Wollongong Local Planning Panel Assessment Report | 11 December 2019

WLPP No.	Item No. 2
DA No.	DA-2019/575
Proposal	Residential - Subdivision - Torrens title - two (2) lots, construction of multi dwelling housing (32 dwellings) and Subdivision - Strata title - 32 lots
Property	7 Dawson Street, FAIRY MEADOW NSW 2519 Lot X DP 408389
Applicant	E Planning Pty Ltd
Responsible Team	Development Assessment & Certification – City Centre (NM)

ASSESSMENT REPORT AND RECOMMENDATION

1 Solar Access
1:50

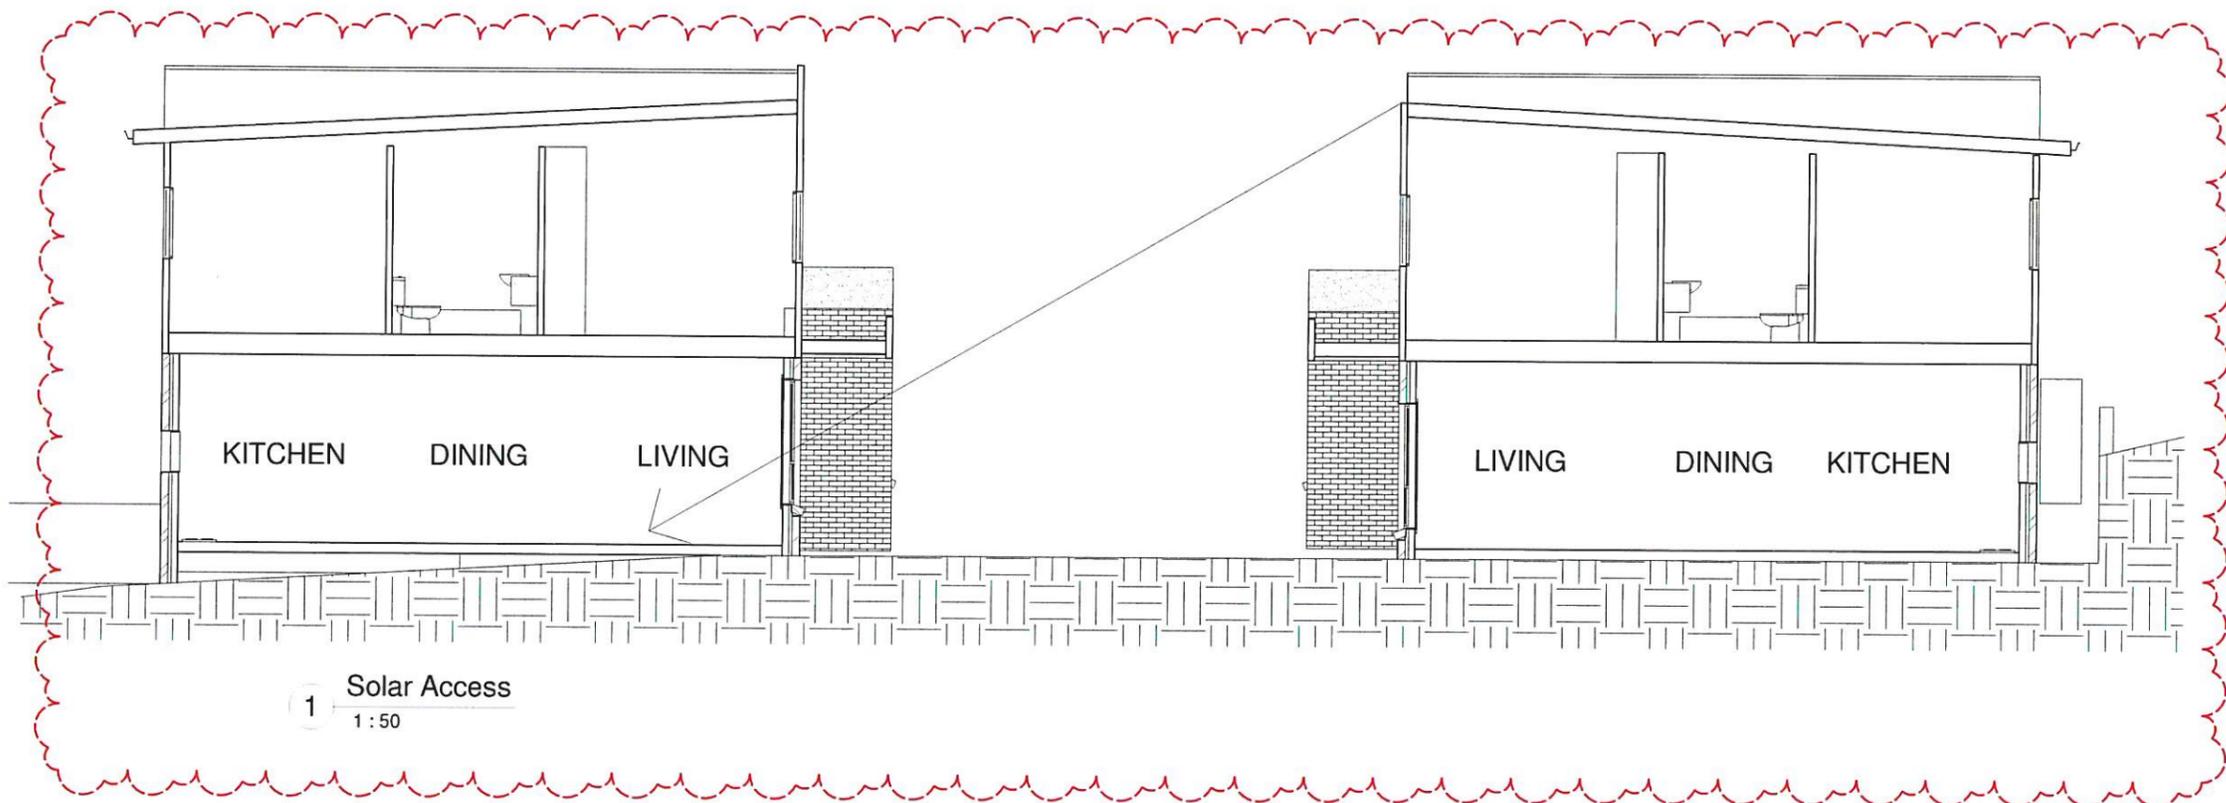
The proposed plans do not demonstrate a suitable level of amenity for future residents. Appropriate levels of solar access have not been shown into the POS areas or north facing living rooms windows of several dwellings.
